**Economic and Social Council**Distr.: General
11 August 2023

World Forum for Harmonization of Vehicle Regulations**Working Party on Lighting and Light-Signalling****Eighty-ninth session**

UN Regulation No. 10 (Electromagnetic Compatibility)**Proposal for a new 07 series of amendments to UN Regulation No. 10 (Electromagnetic compatibility)****Submitted by the expert from by the Informal Working Group on Electromagnetic Compatibility***

The text reproduced below was prepared by the experts from the Informal Working Group on Electromagnetic Compatibility (IWG EMC), with the aim to develop a new 07 series of amendments to UN Regulation No.10. The proposed modifications to the current text of the UN Regulation are marked in bold for new or strikethrough for deleted characters.

"Figure 1

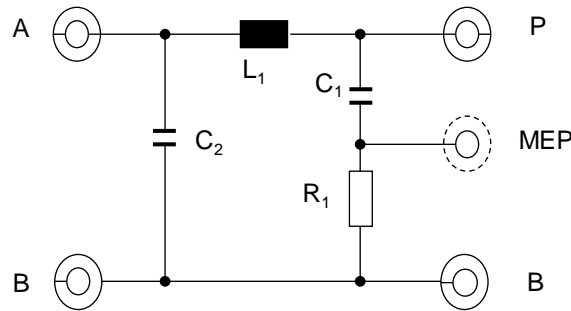
Paragraph 1., figure 1, amend to read:

"Figure 3

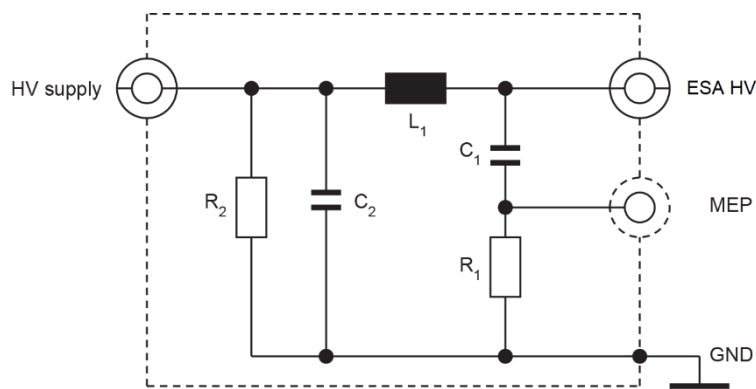
Paragraph 2., figures 3, 4 and 5, amend to read:

"Figure 4

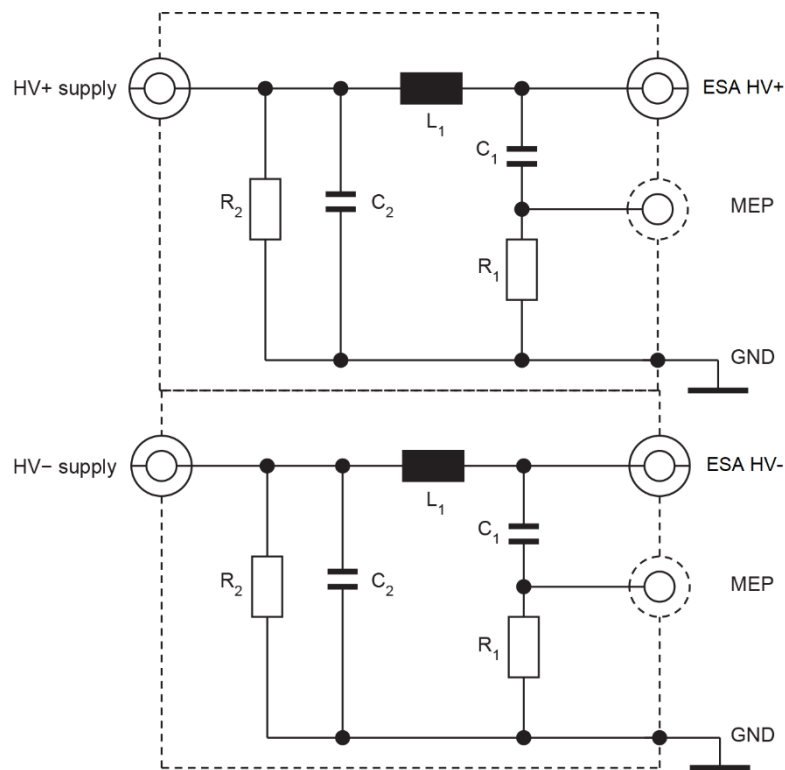
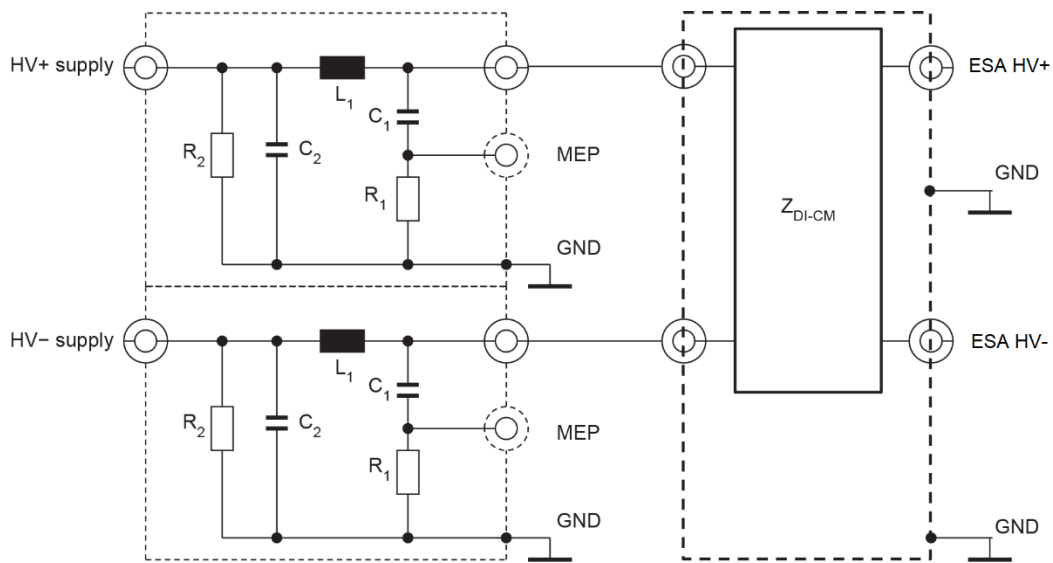
If unshielded HV ANs are used in a single shielded box, then there shall be an inner shield between the HV ANs as described in Figure 4."

An optional impedance matching network may be used to simulate common mode / differential mode impedance seen by the ESA plugged on HV power supply (see Figure 5).

Figure 1
Charging mode configuration for Annex 4

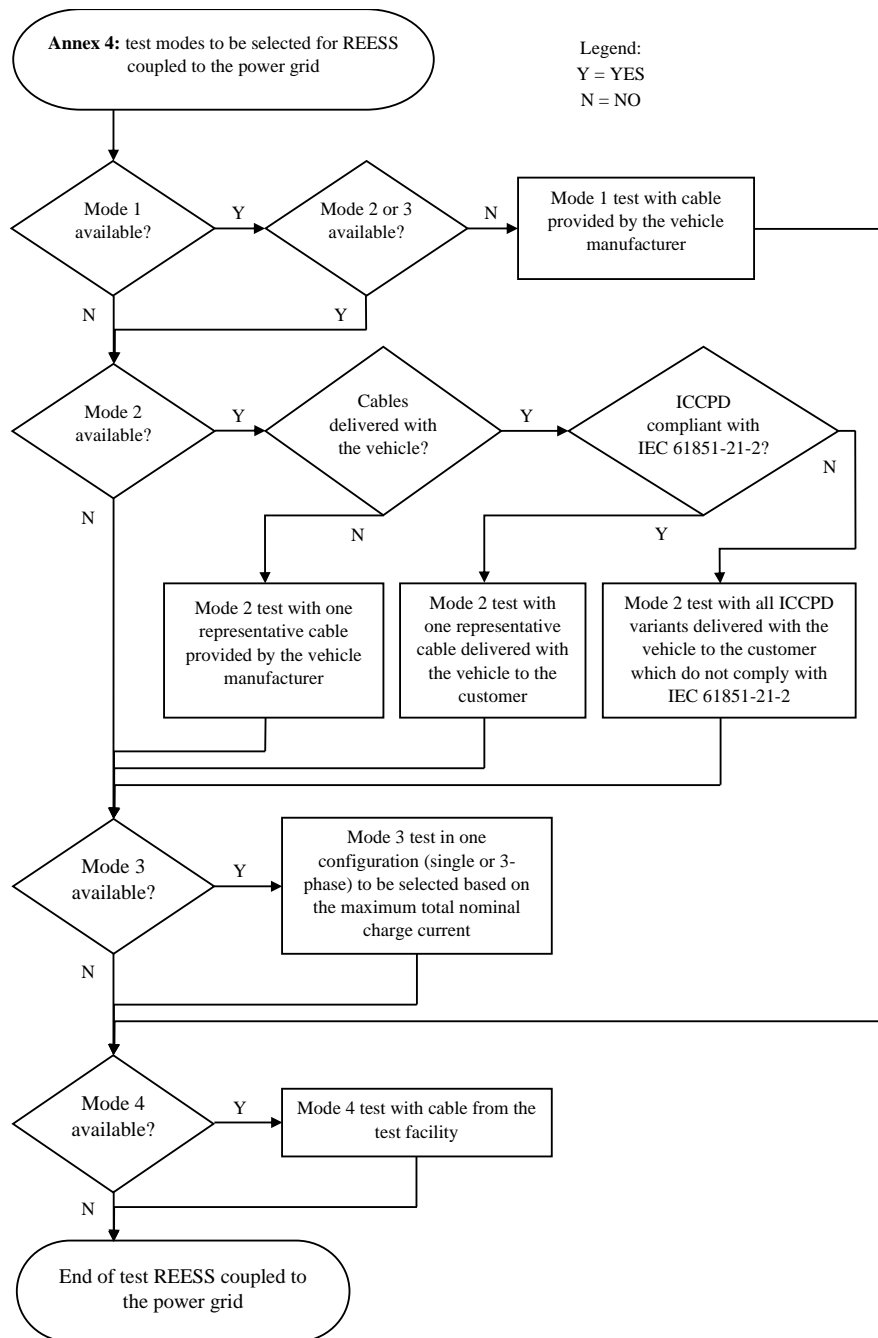
- "2.2. Vehicle in configuration "REESS charging mode coupled to the power grid".

The vehicle shall be tested in the charging mode configuration (if available on vehicle) as defined in flowchart of figure 1

Vehicle in configuration "REESS charging mode" coupled to the power grid:

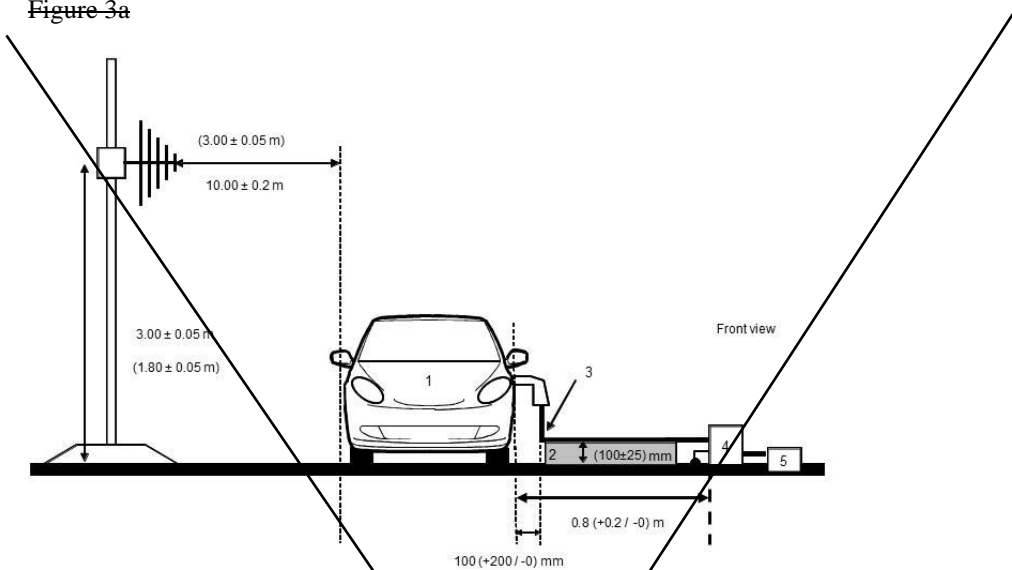
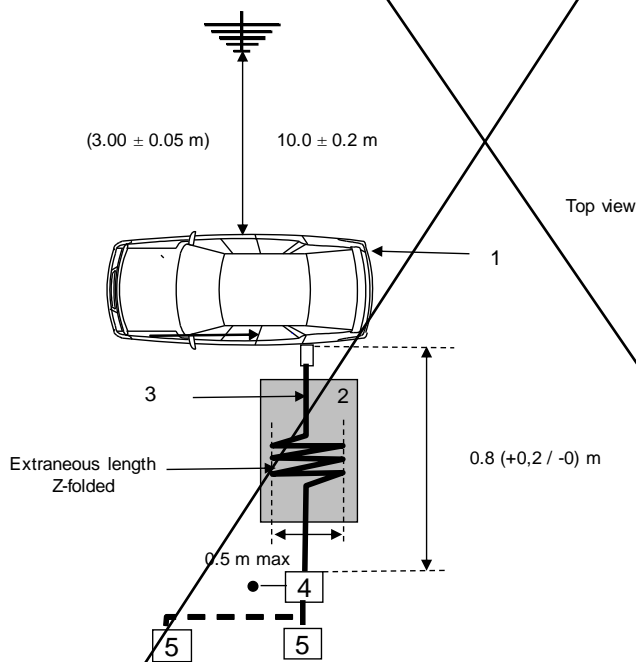
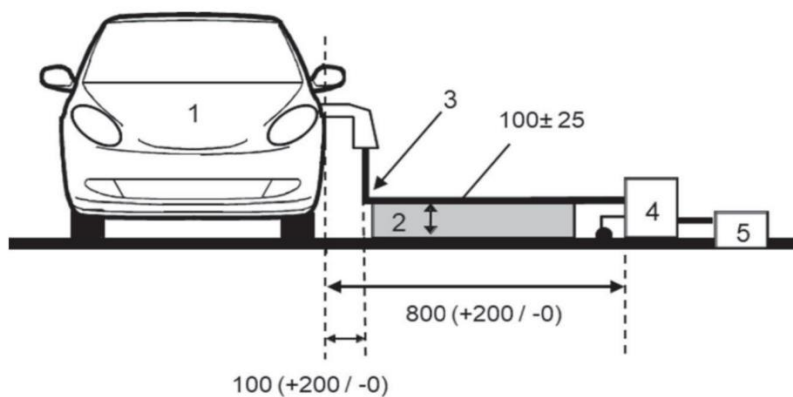
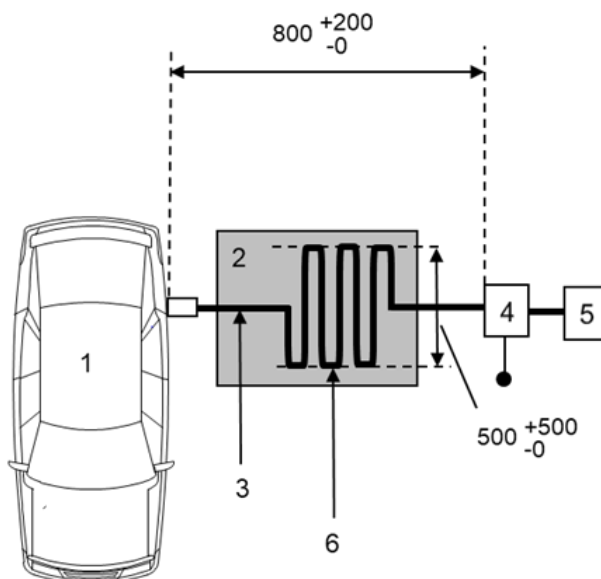
The power charging harness shall be placed in a straight line between the AMN(s) and the vehicle charging plug and shall be routed perpendicularly to the vehicle longitudinal axis (see Figure 3da and Figure 3c). The projected harness length from the side of the AMN(s) to the side of the vehicle shall be 0,8 (+0,2 / -0) m as shown in Figure 3db and Figure 3ed.

Example of test setup for vehicle with socket located on vehicle side (charging mode 3 or mode 4, with communication)

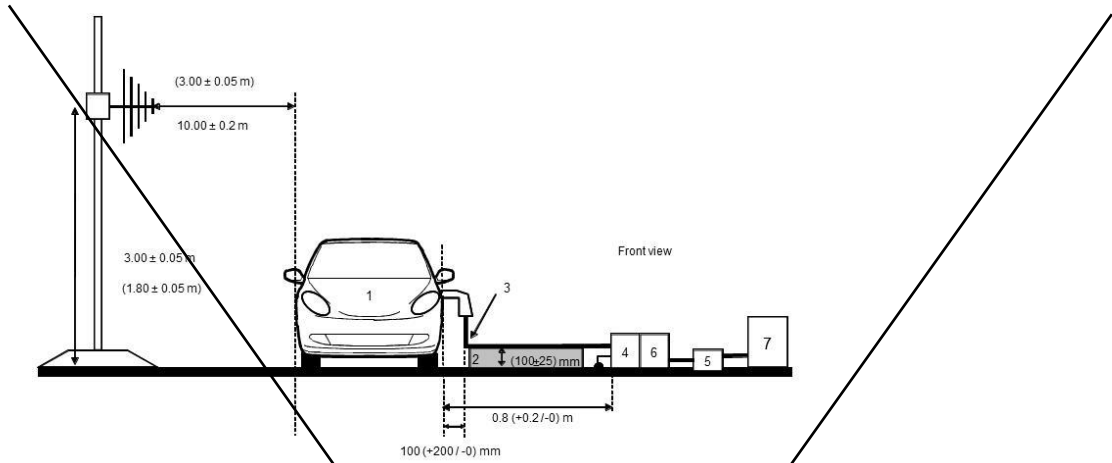
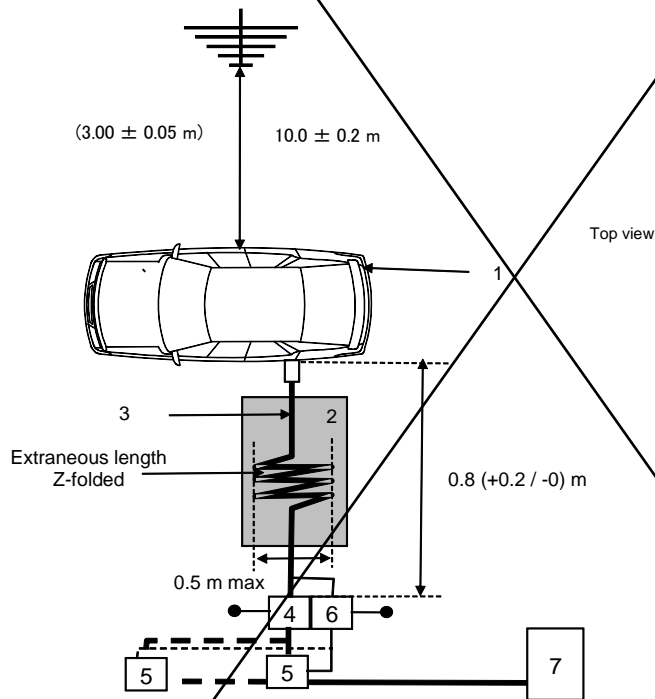
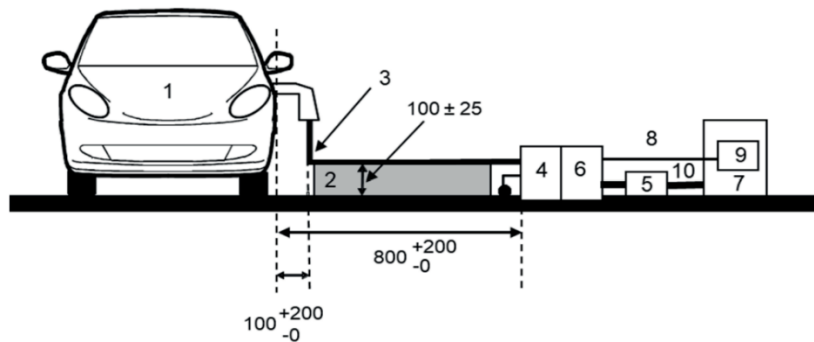
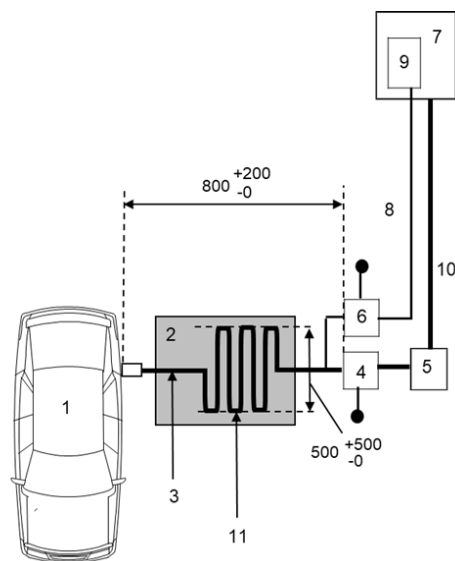
The power charging local/private communication harness shall be laid out in a straight line between the AMN(s) / DC-charging-AN(s) / AAN(s) and the vehicle charging socket and shall be routed perpendicularly to the vehicle's longitudinal axis (see Figure 3f and Figure 3g). The projected harness length from the side of the AMN(s) to the side of the vehicle shall be 0,8 (+0,2 / -0) m **as shown in Figure 3f and Figure 3h.**

Figure 1

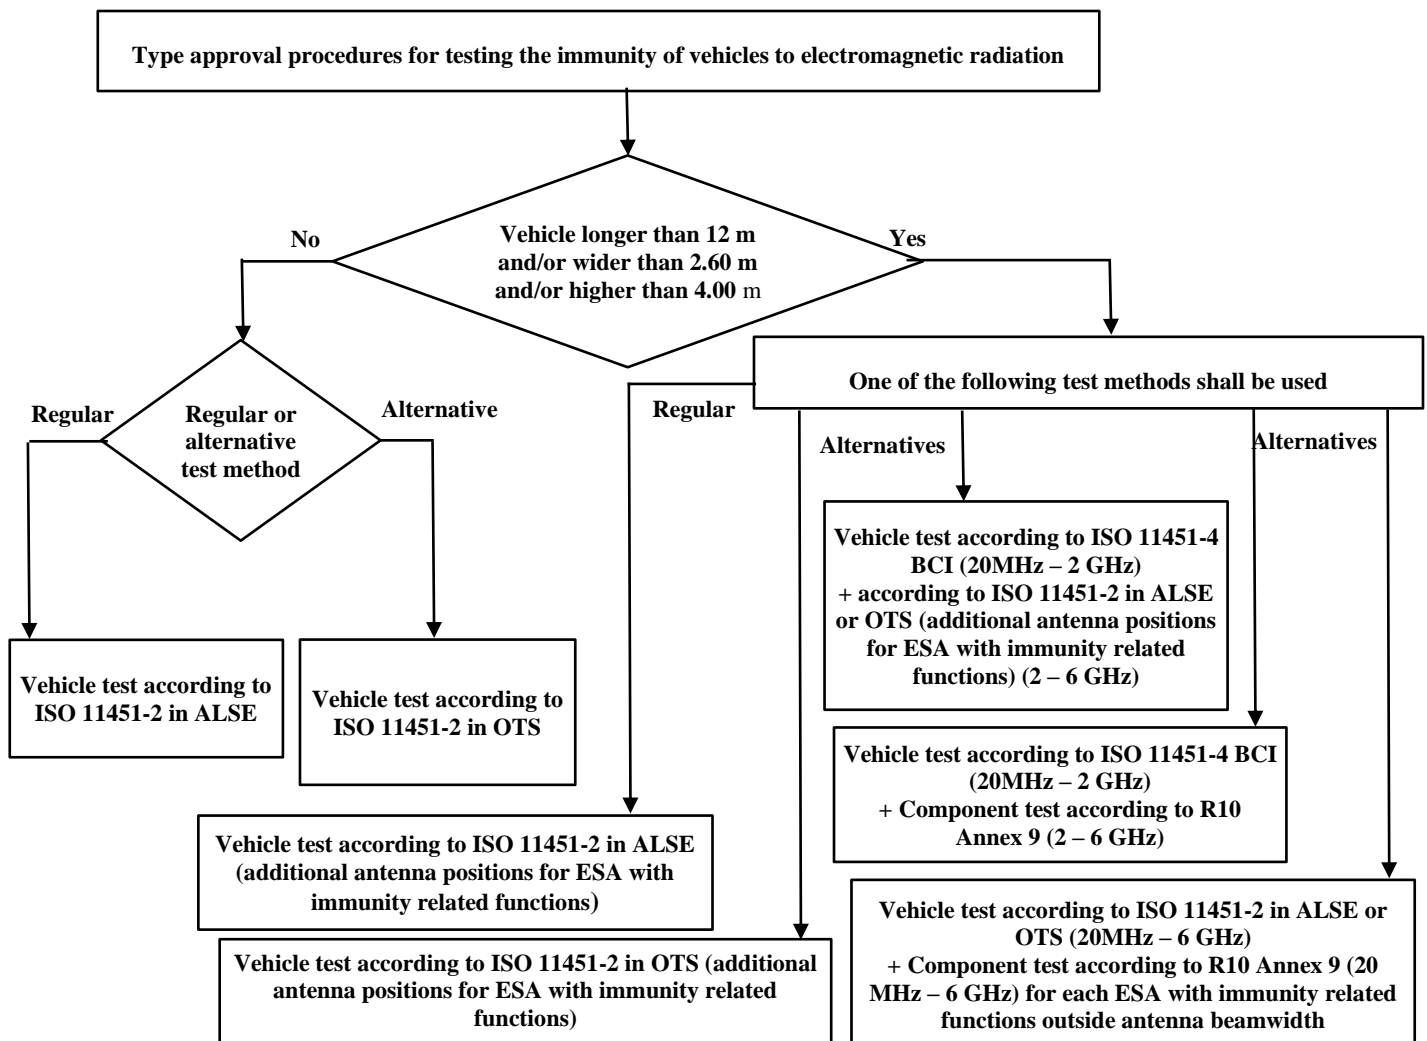
Insert a new paragraph 1.4., to read:

"1.4 Applicability of test methods:

Figure 2
Charging mode configuration for Annex 6"

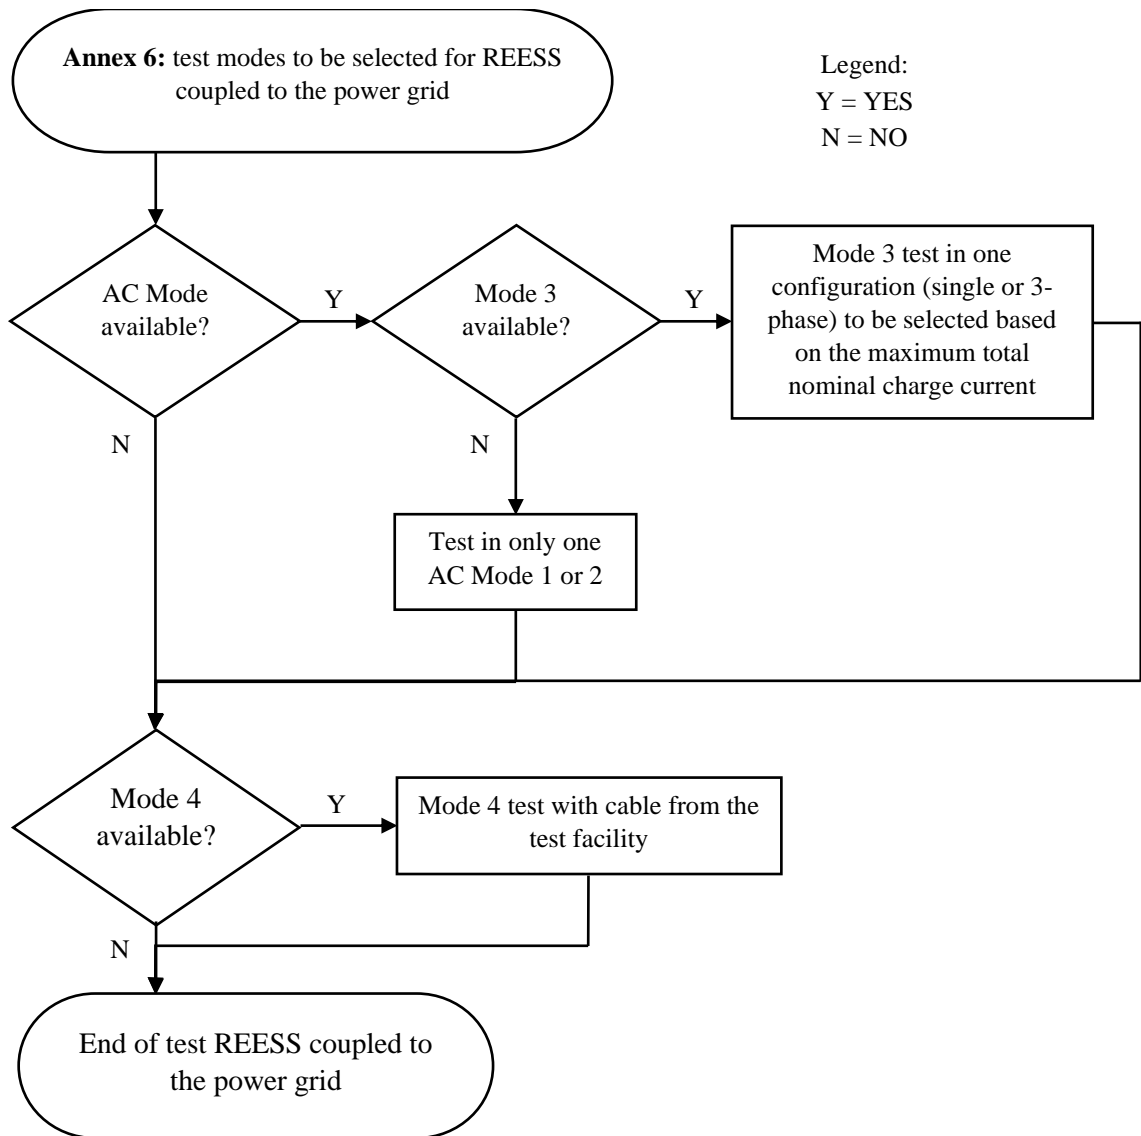
"2.2.1.1. The vehicle shall be immobilized, the engine(s) (ICE and / or electrical engine) shall be OFF and in charging mode.

The vehicle shall be tested in the charging mode configuration (if available on vehicle) as defined in flowchart of figure 2

Figure 1
Charging mode configuration for Annex 11]

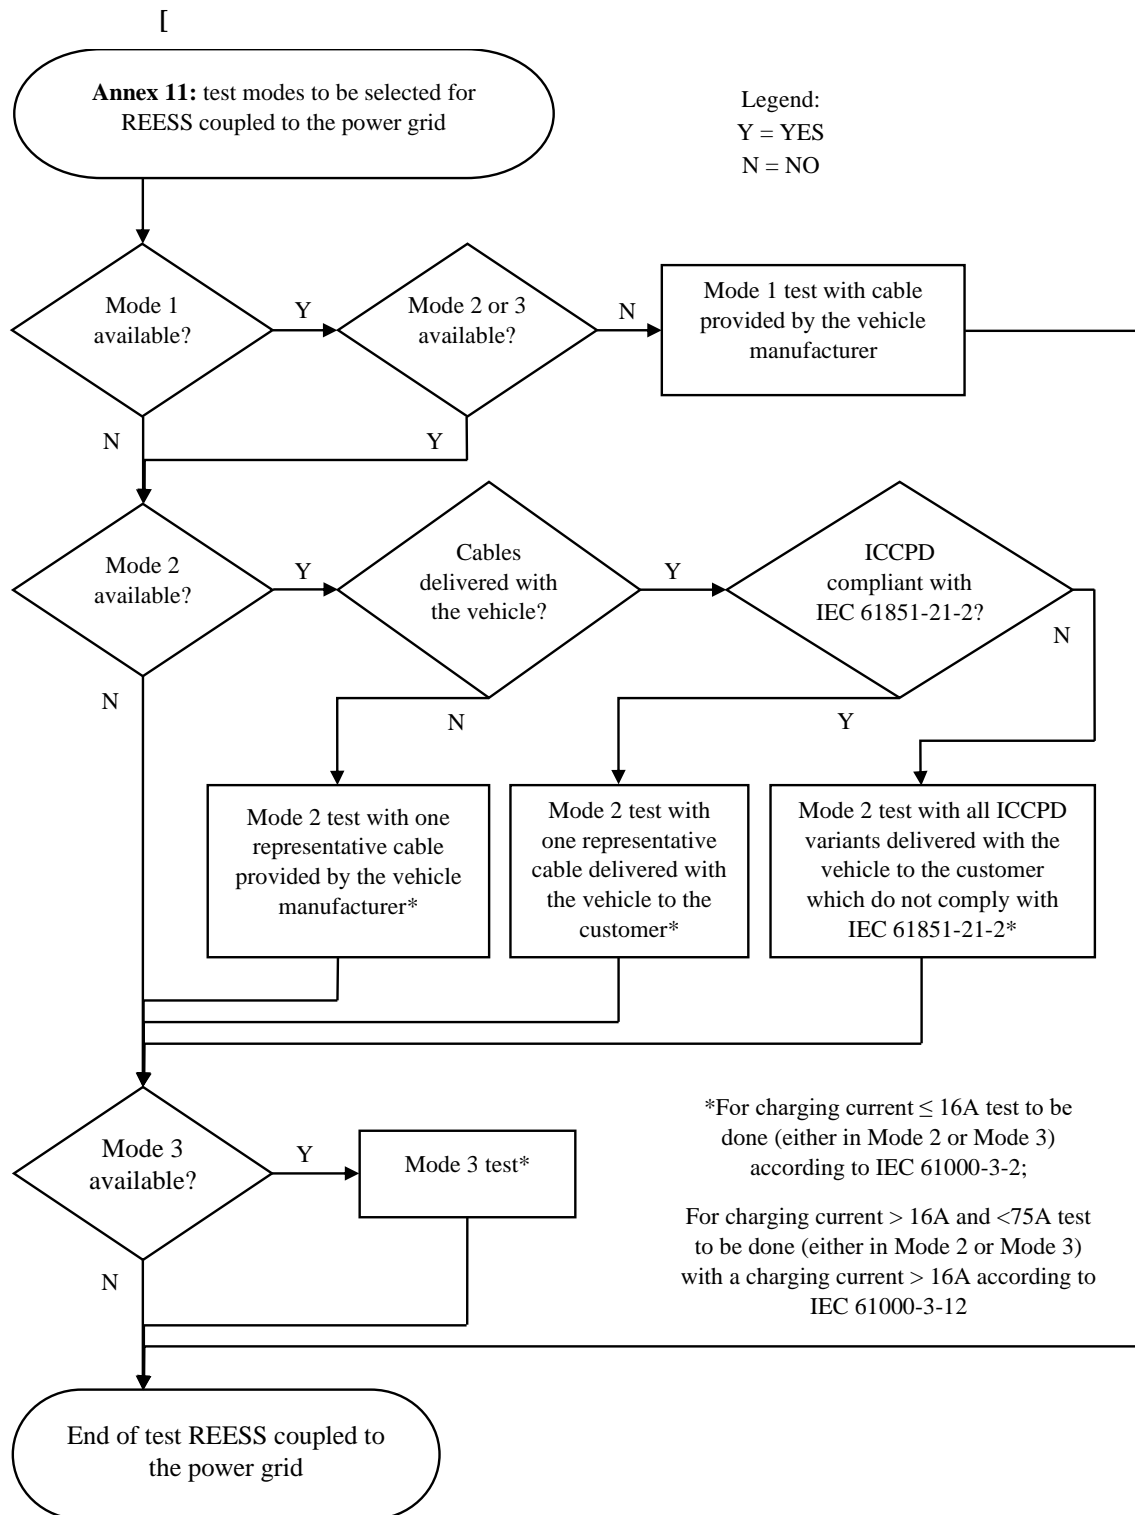
The vehicle shall be tested in the charging mode configuration (if available on vehicle) as defined in flowchart of figure 1
